**Review & Evaluation of FEMA's Coastal Flood Risk Study**  
Data and Documents Review Technical Memorandum (Deliverable 4.1)  
Task Order #1778-01

October 1, 2020 | 13134.201.R3.Rev0

**PALM BEACH COUNTY**  
*Discover the Palm Beaches...  
 the Best of Everything*

Figure 2.1: Tracks of selected Validation Storms (FEMA, 2015; [4]).

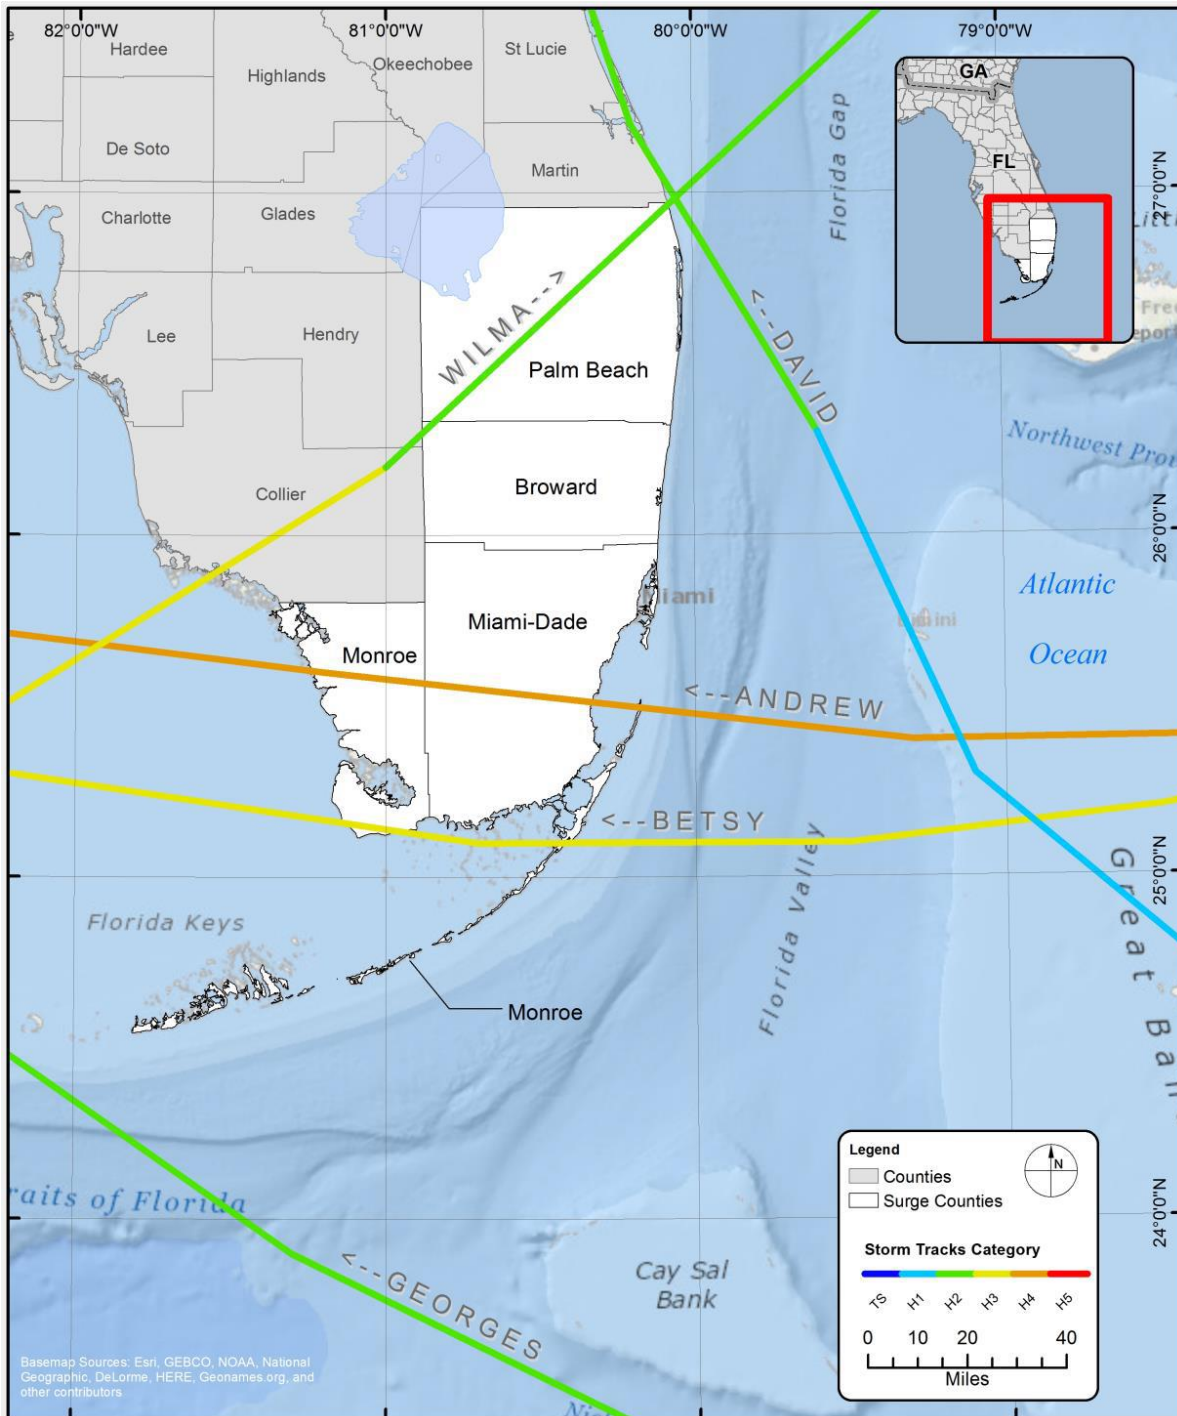
In summarizing its basis for selecting validation storms, FEMA defined one basis as being “water level records are available at more than 15 stations” [4]. This was inferred as FEMA’s threshold for satisfying its criteria regarding availability of water level data and spatial distribution throughout the study area (3<sup>rd</sup> bullet in the list above). According to the information presented, National Oceanic Atmospheric Administration (NOAA), United States Army Corps of Engineers (USACE), United States Geological Survey (USGS), and South Florida Water Management District (SFWMMD) stations within the study area were evaluated. Figures presented by FEMA

Subsequently, FEMA makes the following statements calling in to question the appropriateness of selected validation storms in performing the model validation of water levels.

- While Hurricanes Betsy, Andrew, and Wilma “produced significant surge” near the landfall locations, the storms “do not provide wide coverage of recent surge levels in the study area as they did not produce significant surge in southern Palm Beach or Broward Counties or in the Florida Keys” [9].

- With respect to Hurricane Betsy, “very little observed data are available for validation purposes” [9].
- “Inclusion of Hurricanes David and Georges recognized the need to evaluate multiple storms and storms with landfall locations that cover the study area. However, these storms do not represent ideal validation cases as their surge values occur well below the 1%-annual-chance levels targeted by the modeling effort” [9].

Inclusion of other validation storms in addition to (or in substitution of) those selected appears warranted in order to improve FEMA's model validation and representation of storm surge throughout the study area. FEMA should have included more recent storms with storm tracks adjacent but in close proximity to the study area, higher storm surge values, and greater spatial distribution of measured water level data. For example, Hurricanes Frances and Jeanne are potential storms that should be considered for the following reasons.

Figure 2.2: Tracks of Validation Storms compared to 2004 Hurricanes (screen capture NOAA, 2020). Hurricanes Frances (top) and Jeanne (bottom)

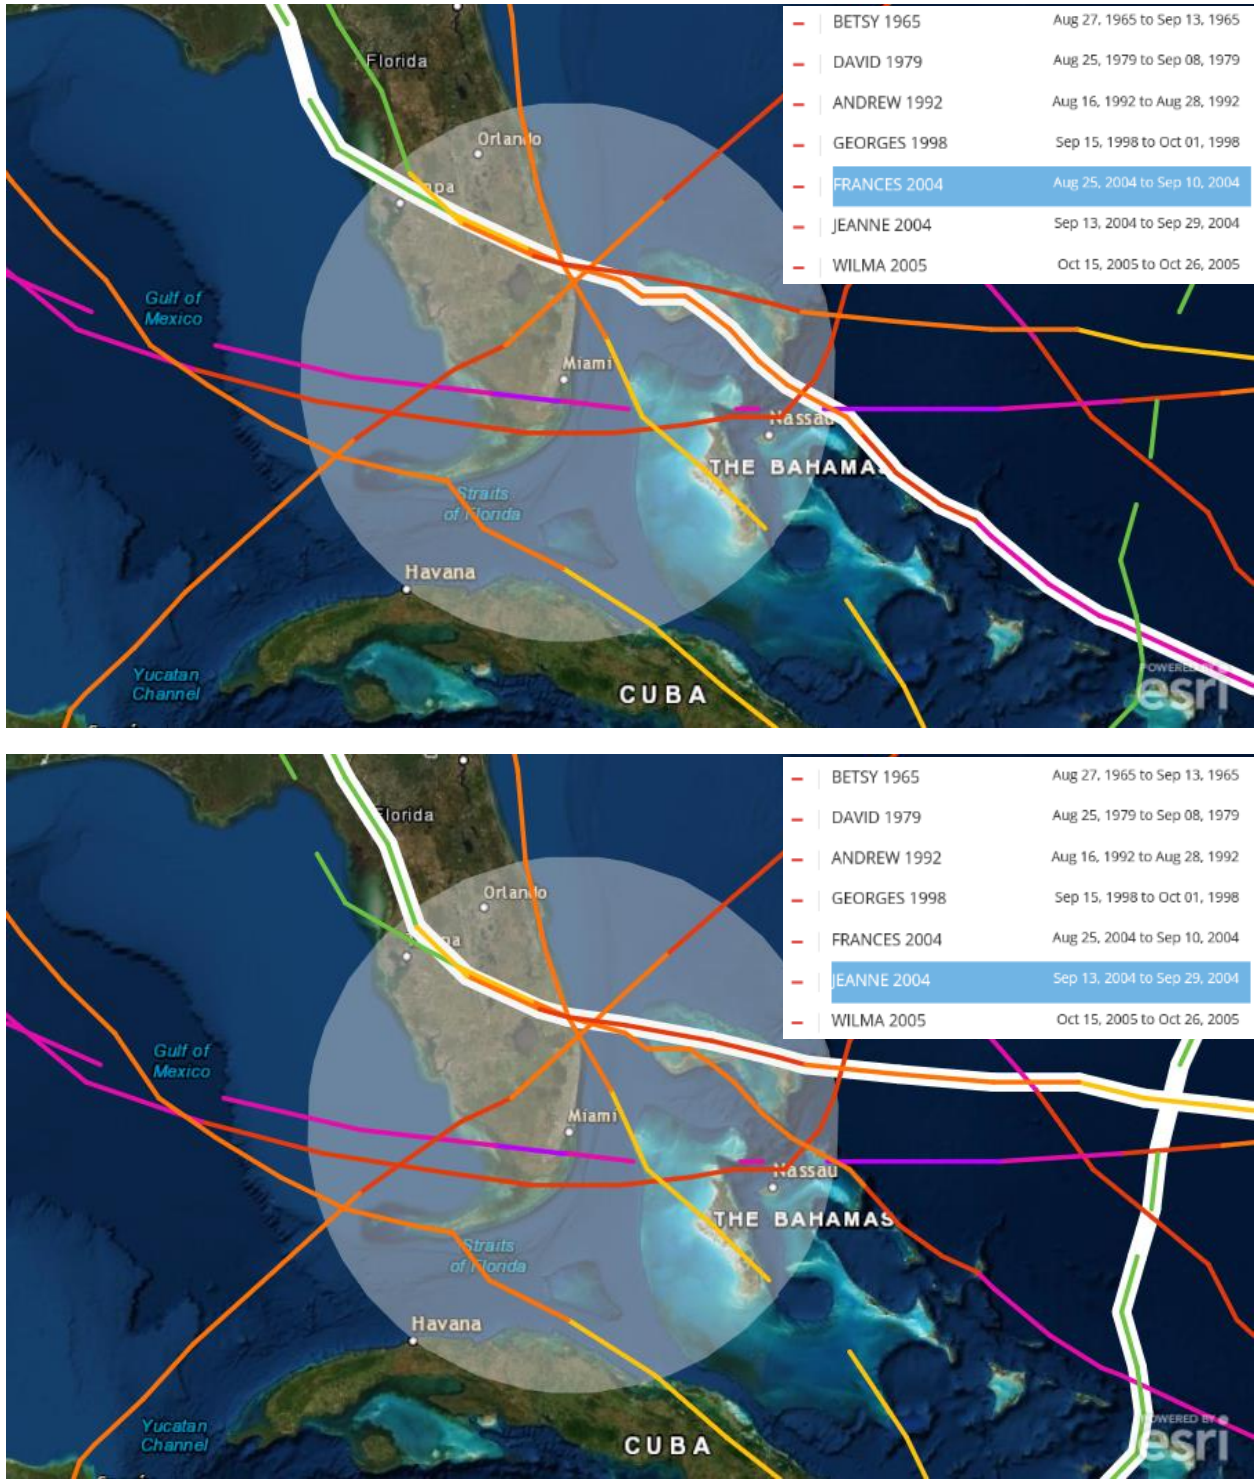
- The storms provide a basis for representing storm surges along the Atlantic coastline of the study area and in particular Palm Beach County. The hurricanes occurred more recently (September 2004) as compared to the selected storms and more robust measured water level data is available. The more northerly track of the hurricanes (Figure 2.2) would reduce the dependence on the Key West station while representing storm surges experienced in the northern portion of the study area.

- The storms passed within 200 nautical miles of Miami Beach. The hurricanes both made landfall immediately north of the study area in Martin County at similar locations as Hurricane David, which was a selected validation storm.

- The storms were of historical significance to the study area as reported by FEMA. The hurricanes resulted in “fatalities, property damage, power outages, and flooding across Palm Beach County” and that Hurricane Frances resulted in “approximately \$34,000,000 in property damage in Miami-Dade County” [1].

- The storms passed closer to a location of measured wave data (NOAA's wave buoys located offshore of Cape Canaveral) than the other selected validation storms. It is anticipated that the hurricanes would provide an opportunity to perform validation of modeled wave conditions, which was not possible for the selected storms (see Section 3).

- The storms were used to validate the SWAN+ADCIRC model for FEMA's East Coast Central Florida (ECCFL) coastal study (2014). Inclusion of Hurricanes Frances and Jeanne as validation storms for the SFL study would likely provide added value in improving agreement with the ECCFL study (see Section 4).

Figure 3.1: Stations with Measured HWM and Hydrograph for All Storms (FEMA, 2017; [9]).

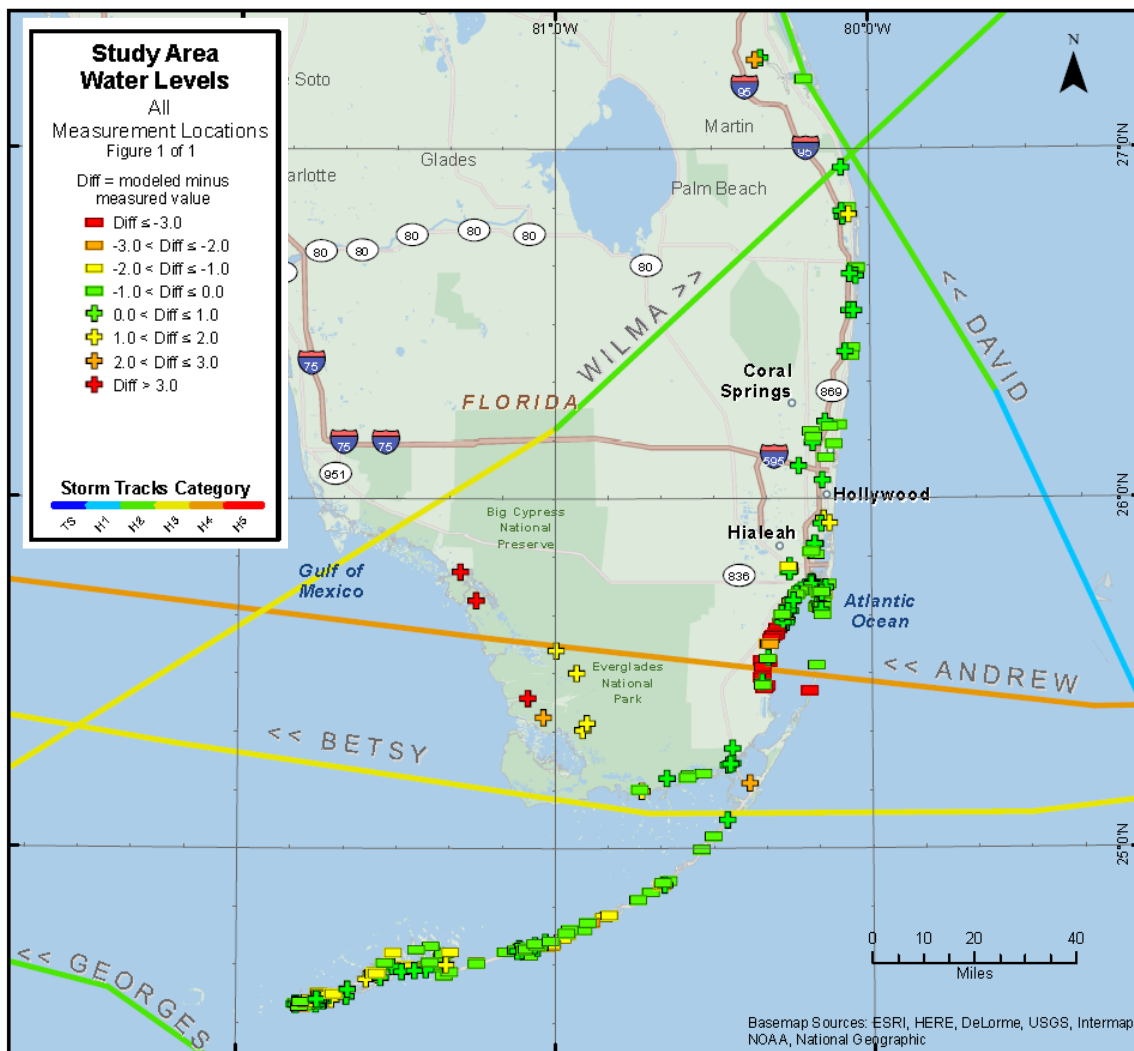
The following observations were made from Figure 3.1 and Figure 3.2 suggesting that the proximity of measured water levels to the storm track, the gage locations, and the reliability of measured data are important to consider in the model validation.

- There was greater difference between modeled and measured water levels along the coastlines of Biscayne Bay in Miami-Dade County and Everglades National Park in Monroe County as compared to elsewhere in the study area (Figure 3.1). The modeled water levels range 2 to 3+ feet above/below the measured data. These differences are primarily associated with Hurricane Andrew in Miami-Dade County and Hurricane Wilma in Monroe County.

**Figure 3.2: Measured-to-Modeled Peak Water Level Comparison for All Storms (FEMA, 2017; [9]).**

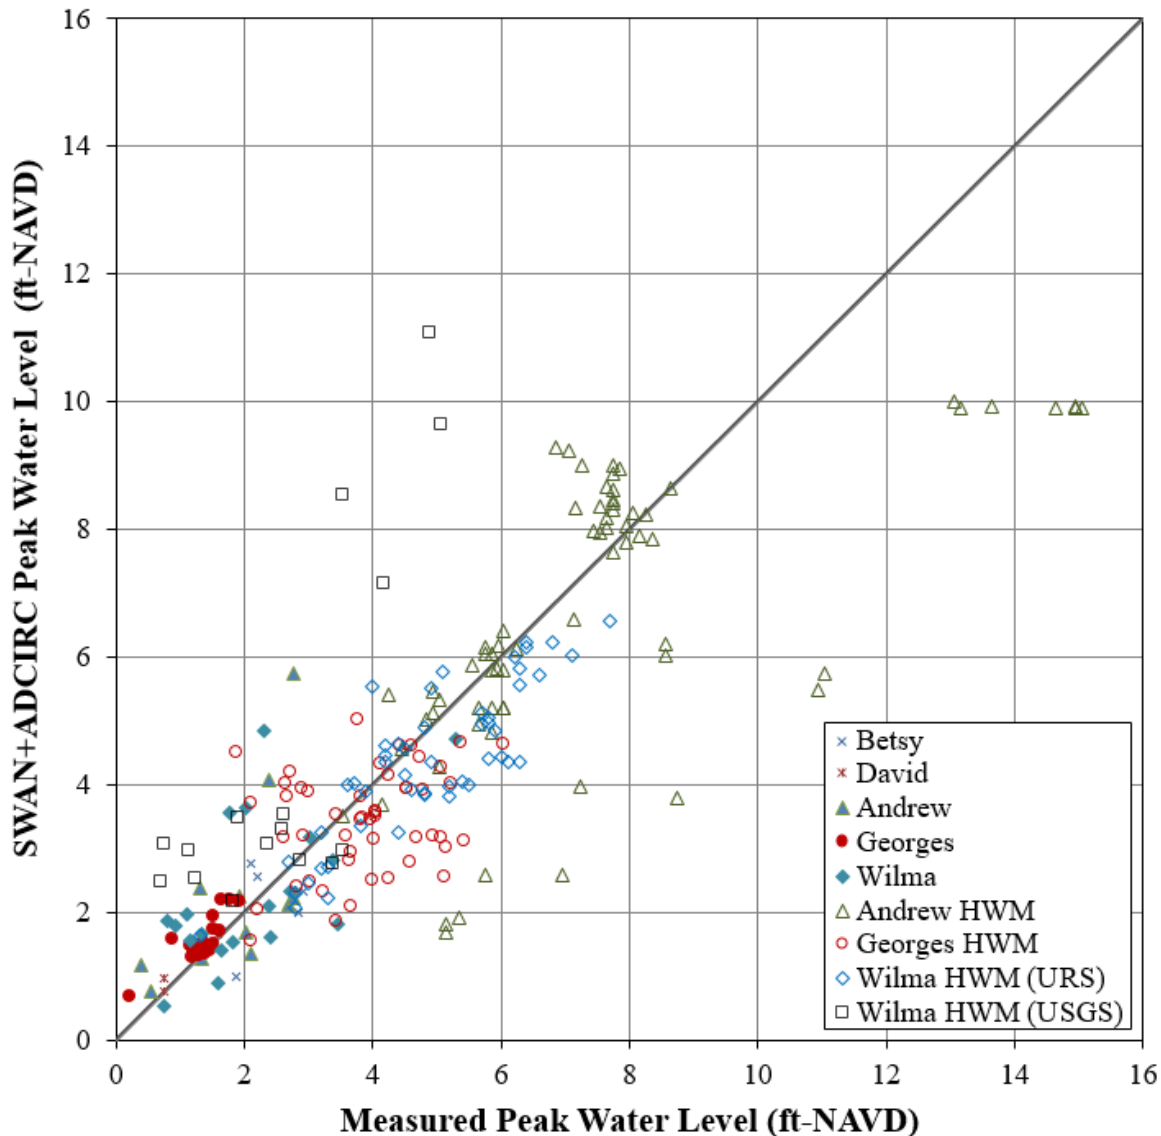
- The modeled water levels agree more closely with measured hydrograph data at lower water levels as compared to higher water levels (Figure 3.2). This is most evident for Hurricanes Andrew and Wilma as shown by the increased clustering of data point along the black, diagonal line at the lower left corner of the figure as compared to moving toward the upper, right corner. Lower water levels generally indicate less influence from storm surge.

- The modeled water levels agree more closely with the measured hydrograph water level data as compared to the measured HWM data (Figure 3.2). This is shown by the increased clustering of data points along the black, diagonal line for hydrograph data (solid symbols) as compared to the increased scatter for the HWM data (open symbols). This may be related to the inherent lower level of accuracy and/or lower reliability of HWM data collected manually during post-storm damage assessments as well as model uncertainty in simulating higher water levels (i.e. storm surge) where HWM are typically collected.

Figure 3.3: Hydrograph for Station S44\_T located in northern Palm Beach County (FEMA, 2017; [9]). Hurricanes Andrew (top), Georges (middle), and Wilma (bottom).

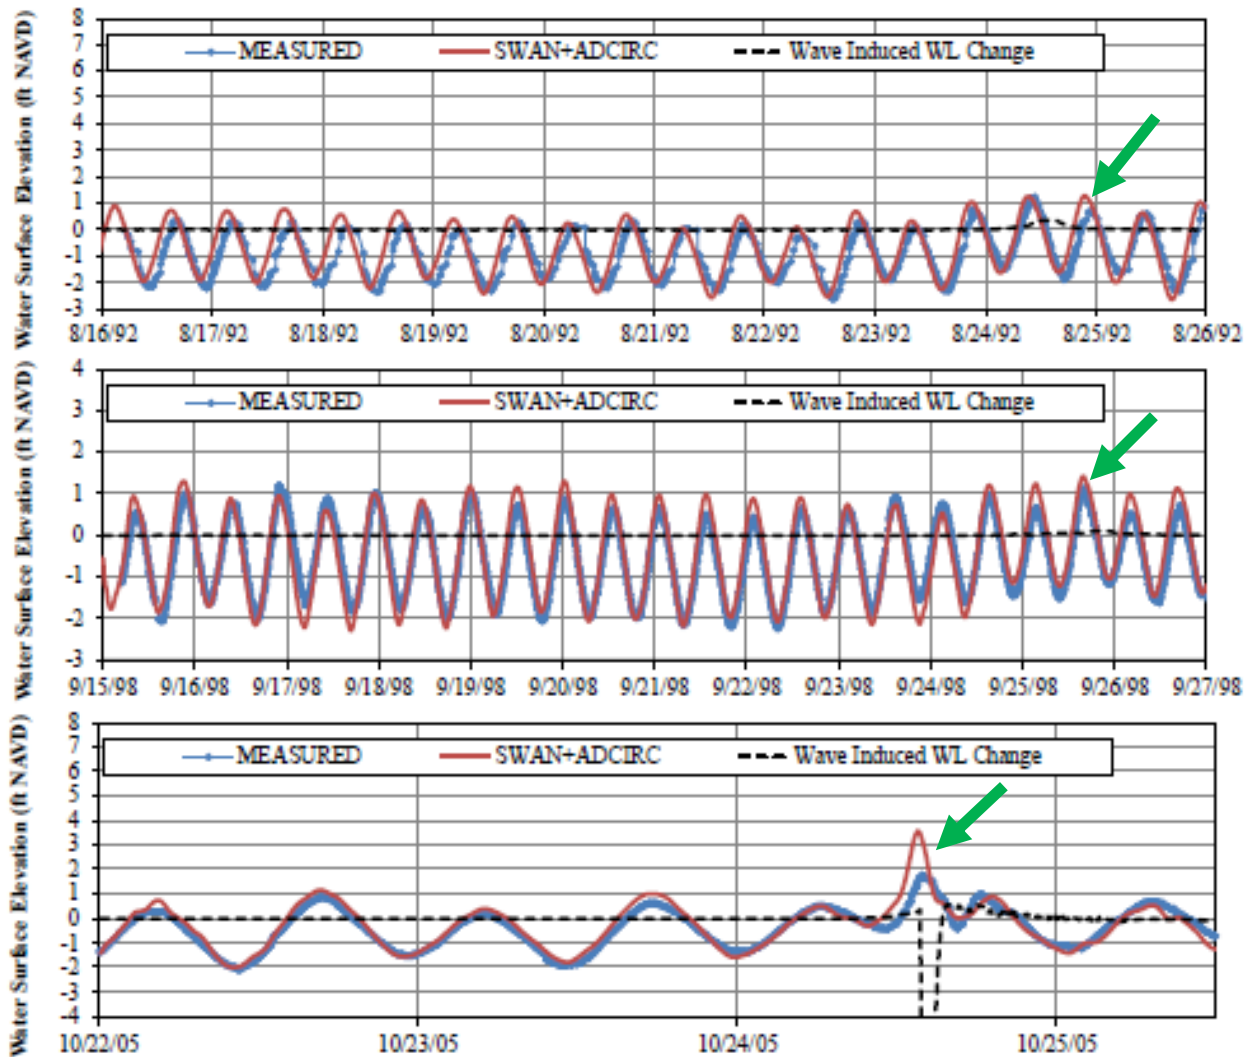
As storm surge decreases to zero due to distance from a storm event or as the storm tracks away from a particular location, changes in water levels are primarily governed by astronomical tides. While it is acknowledged that the extensive model validation resulted in reasonable agreement with measured astronomical tides, less favorable agreement with measured water levels during the simulated validation storm events suggests that the coastal processes associated with storm surge may not be sufficiently represented by the SWAN+ADCIRC model. This concept is highlighted by comparing hydrographs for a given location with a variety of storm tracks. Figure 3.3 shows the hydrograph for the SFWMD S44\_T (DBKey 06675) gage in northern Palm Beach County with the green arrows indicating the peak water levels during Hurricanes Andrew (top), Georges (middle), and Wilma (bottom).

- The gage was located further from the storm tracks of Hurricanes Andrew and Georges and as such the influence of storm surges are expected to be less. The modeled and measured water levels are in better agreement for these storms (differences of -0.06 and 0.21 feet, respectively).
- The gage was located closer to the storm track of Hurricane Wilma. The modeled water level was overestimated 1.81 feet based on the measured data, which indicates that the model over predicted storm surge.

The model validation presented by FEMA is based on the difference between the maximum modeled and maximum measured water levels for the storm event but does not consider the timing (or phasing) of the maximum water levels during the storms. Disregard to the phase shift in the water levels can result in the misrepresentation of the model validation and thus the dynamic influence of storm surge. Figure 3.4 shows the hydrograph for the SFWMD S37A\_T (DBKey 06651) gage in Broward County during Hurricane Wilma. The measured peak water level (green arrow) was 1.59 feet, NAVD88, while the modeled peak (purple arrow) was 0.88 feet, NAVD88, which resulted in a difference of -0.71 feet as reported by FEMA. The modeled water level was approximately -1 feet, NAVD88 at the time of the measured peak, which indicates a difference of approximately 2.59 feet. Differences between modeled and measured peak water levels is the basis for quantifying model bias to over- or underestimate storm surge and model uncertainty; the difference in this instance was approximately 3.5 times greater than reported. The model peak water level reported by FEMA was consistent with the high tides the 2 days prior and the day after the storm suggesting that the model simulated limited (if any) storm surge.
